Service Bulletin

Model : Multi-Output Tray-D1

No.: Acc-160
(FF-T01-W-000068-01)

Subject : EXTRACTION OF FEEDER ASSEMBLY CONNECTOR (J357/J356)

Fig. 1 View from the top for the feeder assembly

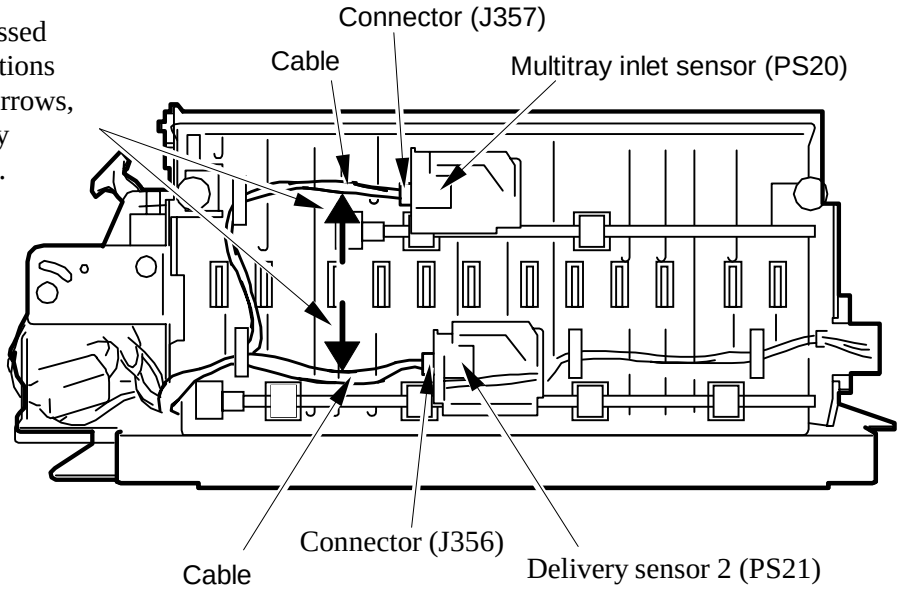
Details : <Symptom>
There are cases where the connector (J357/J356) which connects the feeder assembly multitray inlet sensor (PS20) and delivery sensor 2 (PS21) gets extracted if the cable of the connector is pressed down with the fingers when the feeder assembly is handled during servicing. (Fig. 1)

If the cable is pressed down in the directions indicated by the arrows, the connector may become extracted.

<Factory measures>
The connector (J357/J356) for the multitray inlet sensor (PS20) and delivery sensor 2 (PS21) was changed to another type for more tight fit in order to prevent easy extraction of the connector.

Servicing : When the feeder assembly is handled during servicing, do not press down on the cable of the connector (J357/J356) which connects the multitray inlet sensor (PS20) and delivery sensor 2 (PS21).
Also, the way of holding the multitray 3/D1 when removing it from the packing box as shown in Fig. 2 is recommended.
